M9800A-03

Information Only Service Note

M9800A PXIe Vector Network Analyzer

False alarm on self-test failure on firmware revision of A.13.40.02 - DDR3 memory removal

Self-test

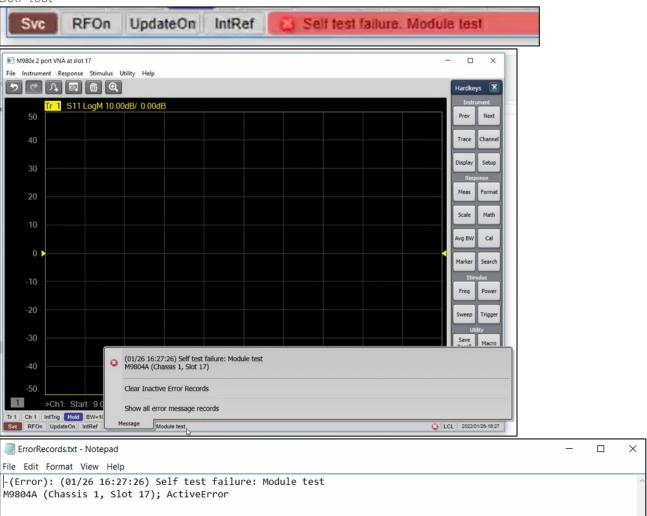
The on board DDR 3 memory in VNA is not in use since its release. With the removal of DDR 3 memory IC on newer M980xA VNA, right after firmware is launched, false alarm (self-test failure) will be reported as shown. This has no impact to VNA performance and specifications.

Similarly, firmware will report a false failure in Operator check. Shown are the error messages example on VNA firmware UI.

For users with firmware revision of A.13.40.02, Update firmware to revision A.13.70.02 or newer to resolve this false alarm on self-test.
